**Economic and Social Council**Distr.: General  
20 September 2010Original: English  
English and French only

**World Forum for Harmonization of Vehicle Regulations****Working Party on Pollution and Energy****Sixty-first session**

**Tractors and Non-Road Mobile Machinery (NRMM)****Proposal for a Corrigendum to global technical regulation  
No. 11****Submitted by the expert from the European Commission \***

The text reproduced below was prepared by the expert from the European Commission in order to introduce a number of editorial corrections to improve the text of global technical regulation (gtr) No. 11 concerning the test procedure for compression-ignition engines to be installed in agricultural and forestry tractors and in non-road mobile machinery with regard to the emissions of pollutants by the engine. This document is based on Informal document No. GRPE-60-03 distributed at the sixtieth session of the Working Party on Pollution and Energy (GRPE) (ECE/TRANS/WP.29/GRPE/60, para. 25). Modifications to the current text of the gtr are marked in bold for new or strikethrough for deleted characters.

Figure 7.3  
Test sequence

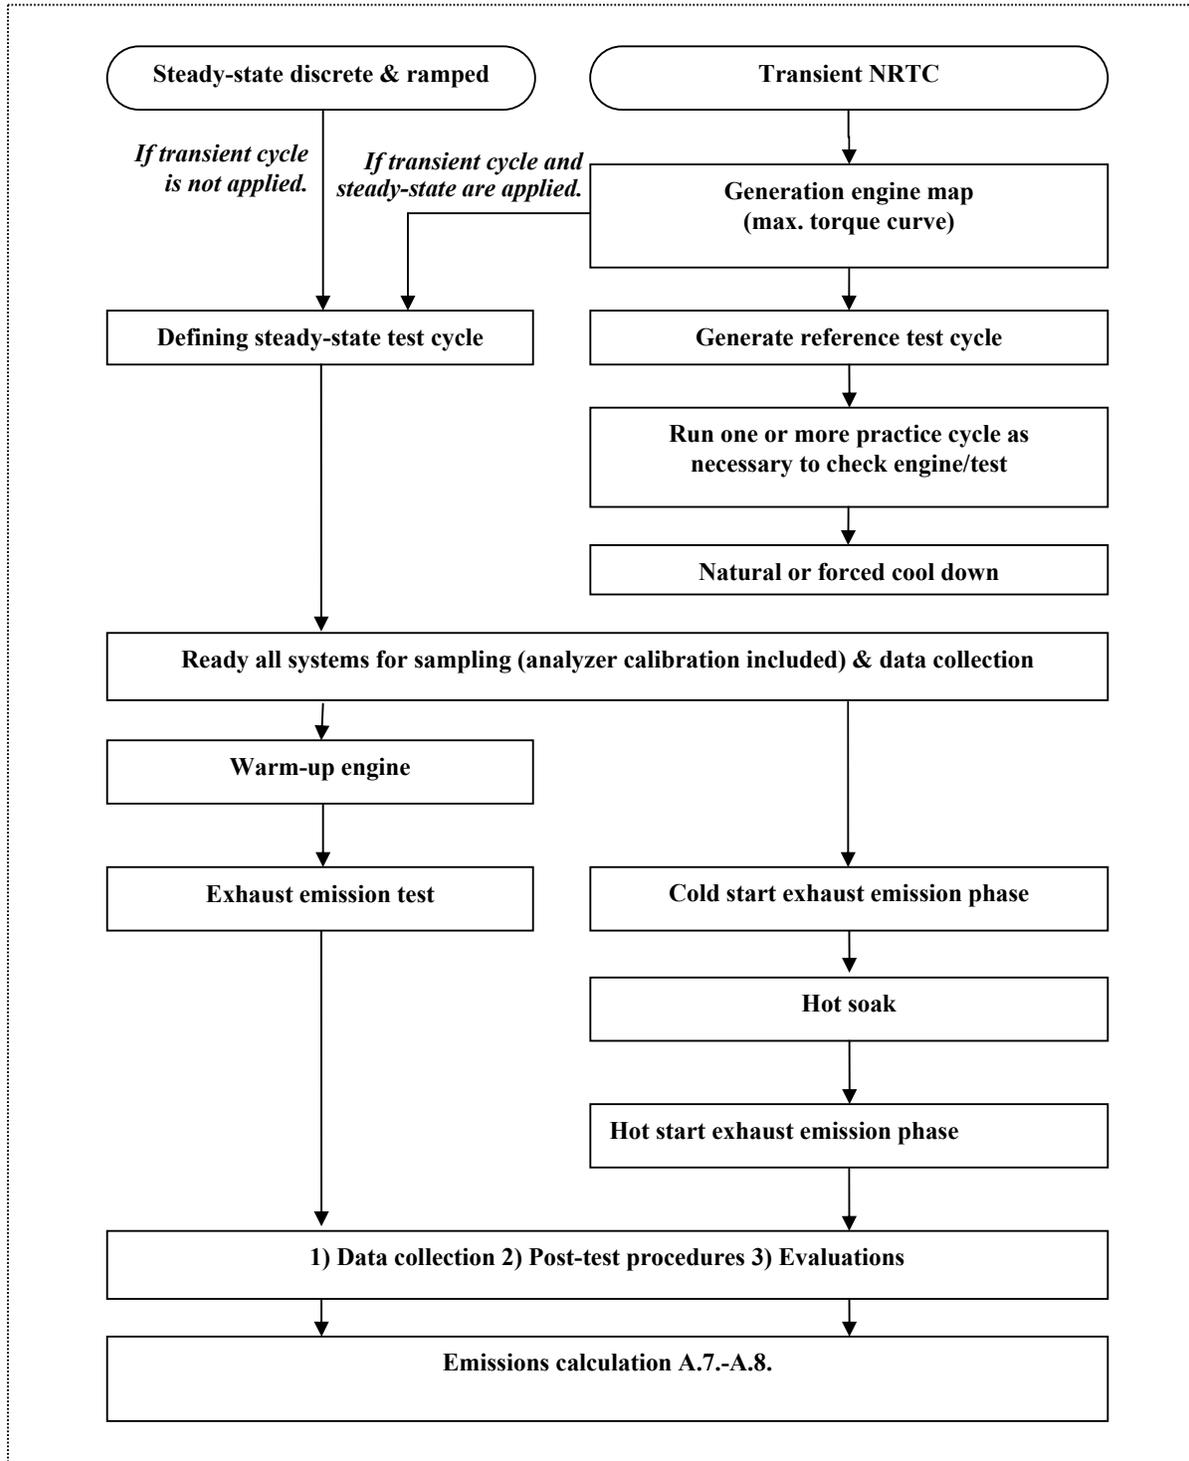
*Paragraph 7.5.*, amend to read:

The following diagram gives an overview about the procedures needed to conduct NRMM test cycles with measuring exhaust engine emissions.

“Figure 8.1

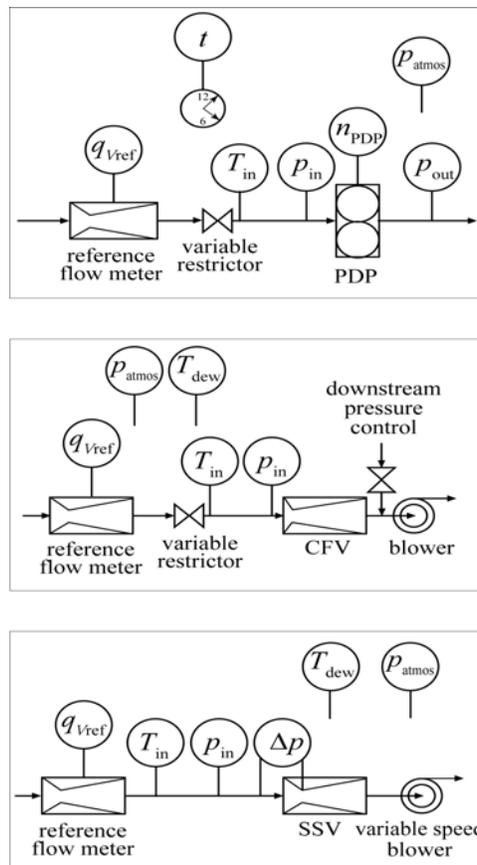
Paragraph 8.1.8.4., figure 8.1, amend to read:

**Schematic diagrams for diluted exhaust flow CVS calibration**

Figure A.4.1

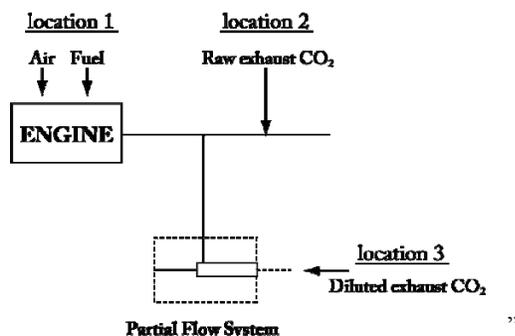
Paragraph A.4.1., amend to read:

Figure A.4.1 shows the sampling points at which the carbon flows shall be checked. The specific equations for the carbon flows at each of the sample points are given below in the following paragraphs.

Figure 7.3  
Test sequence

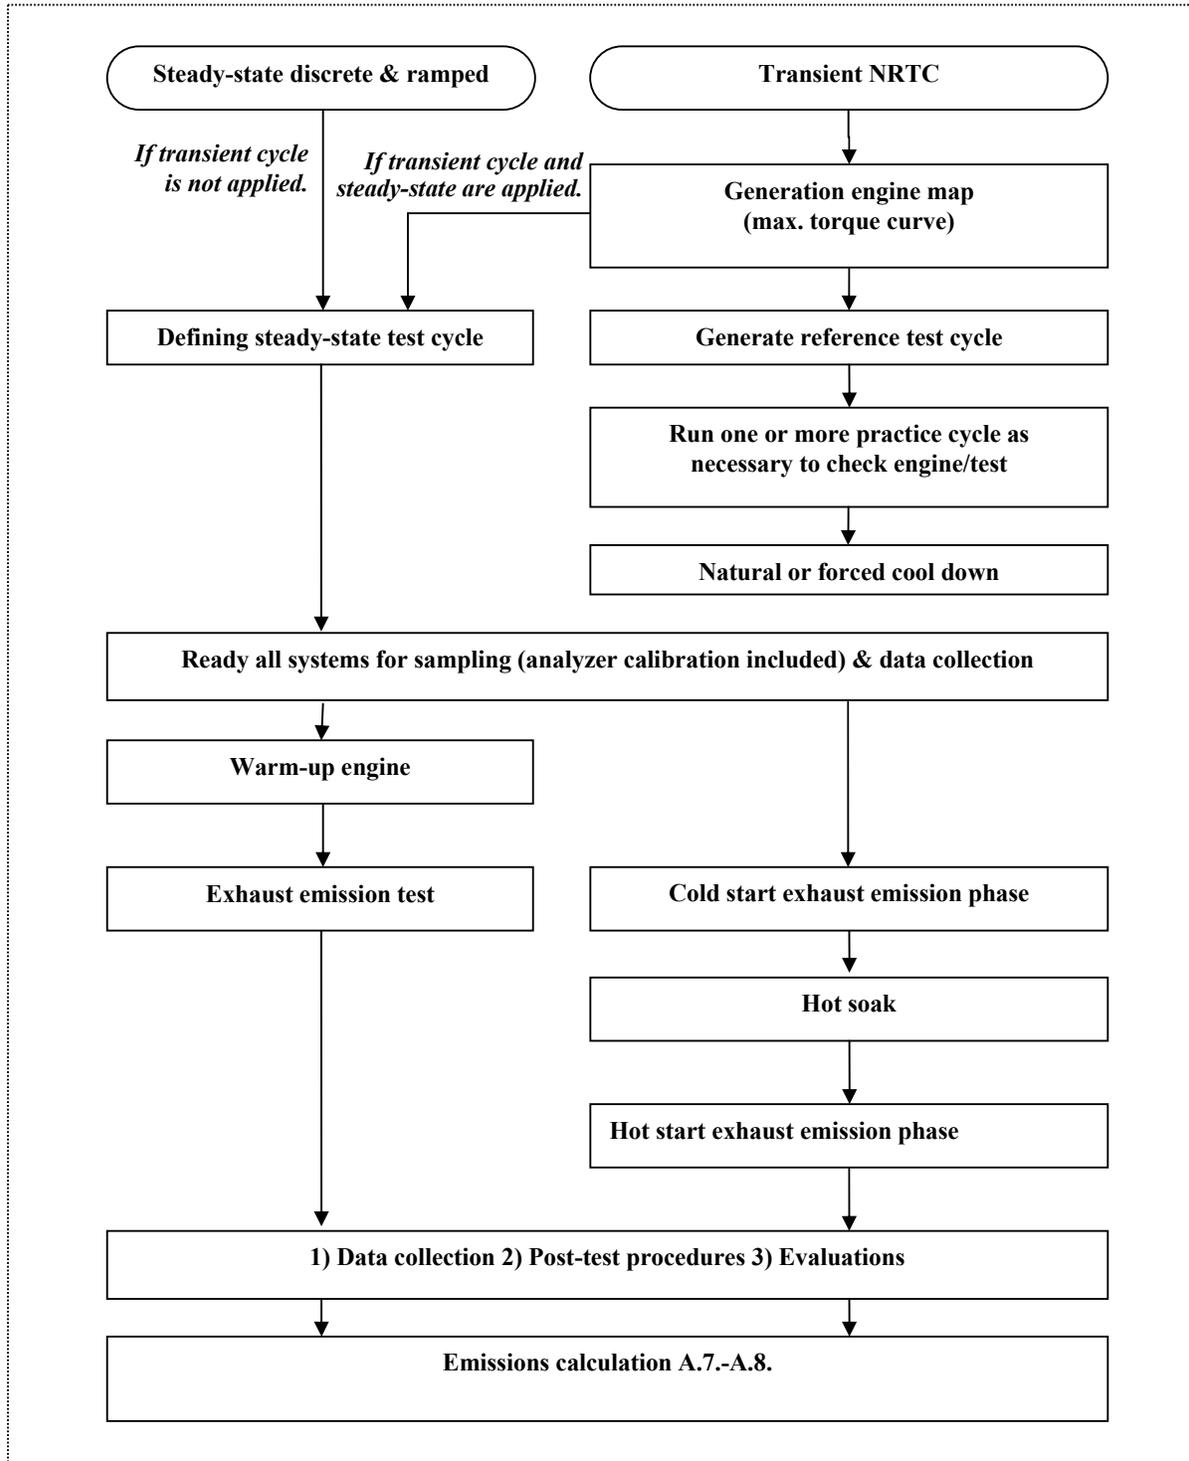
The following diagram gives an overview about the procedures needed to conduct NRMM test cycles with measuring exhaust engine emissions.

“Figure 8.1

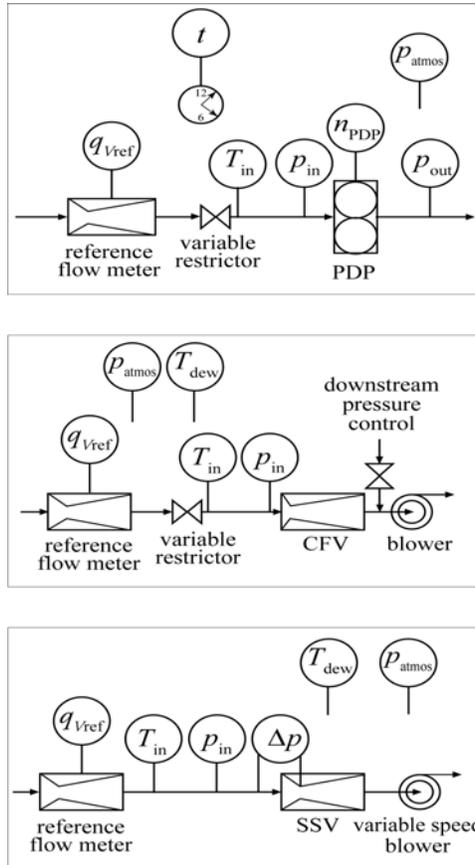
Paragraph 8.1.8.4., figure 8.1, amend to read:

**Schematic diagrams for diluted exhaust flow CVS calibration**

Figure A.4.1

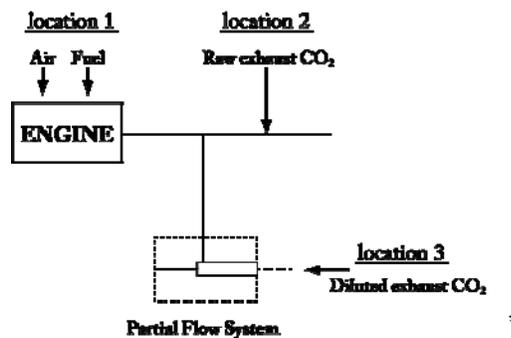
Figure A.4.1 shows the sampling points at which the carbon flows shall be checked. The specific equations for the carbon flows at each of the sample points are given below in the following paragraphs.
